Bulletin No.: 05-08-64-002B

Subject: Door Latch Freezing in Cold Temperatures (Apply Super Lube)

Models: 2005-2007 GM Passenger Cars and Trucks (Including Saturn)
2003-2006 HUMMER H2
2006 HUMMER H3

This bulletin is being revised to add models and model years. Please discard Corporate Bulletin Number 05-08-64-002A (Section 08 — Body and Accessories).

1580414

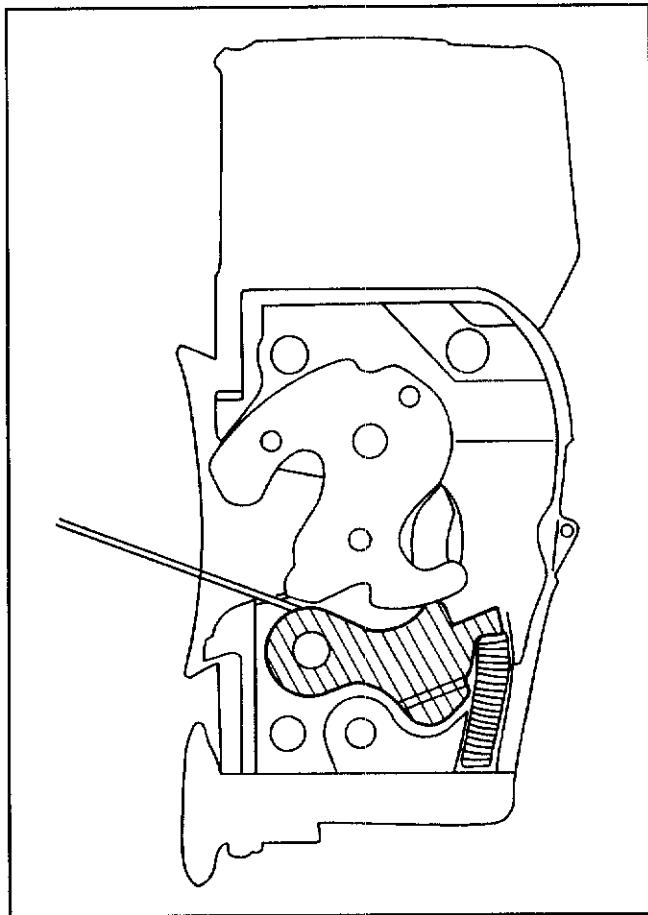
Important: The latch and its backing plate have been removed on the above illustration to show the location for the lube.

2. Allow the latch to completely thaw and apply compressed air for two seconds to the latch to force out any moisture. Refer to the above illustration (slashed area) for the location. Spray GM Super Lube[®] on BOTH sides of the latch detent lever for approximately two to three seconds. Refer to the above illustration (slashed area) for the lube location. Repeat for all door latches. Operate the door latch several times to spread the lubricant on all surfaces.
